## **Aerator 686**

Subject: Main Frame Pivot Pipe damage.

Ref: 02-01 Copyright<sup>®</sup>, 1994. The Toro Company

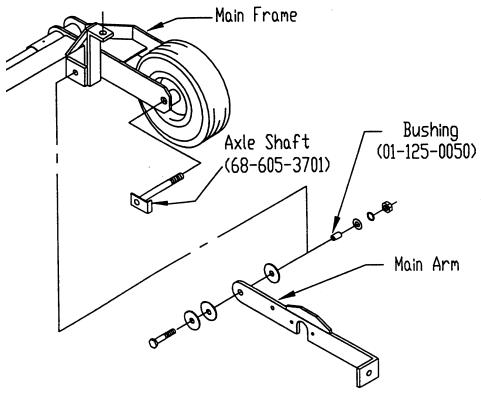
If the Main Arm Bolts are loose or the bushings are worn, the Coring Gang Assembly will move side-to-side and contact the Axle Bolt of the Main Frame Wheel. Should the hand pump be operated to lift the aerator while the Coring Gang Assembly is in contact with the Axle Bolt, the forces generated will begin to twist the Main Frame Pivot Pipe. It is possible to damage the frame to where one wheel can be as much as 8 inches (200 mm) higher than the other.

To increase the clearance and reduce the chance of contact, the original bolt may be replaced by Axle Shaft (68-605-3701). The replacement Axle Shaft eliminates the hex head of the original bolt as shown in the illustration below. Parts are available through your local Toro distributor.

To repair this condition the Main Frame will require straightening or replacement. If Bushing (01-125-0050) is worn it should be replaced and loose fasteners must be kept tight. The operator should be instructed to inspect for interference before lifting and cautioned about excessive resistance while operating the hand pump.
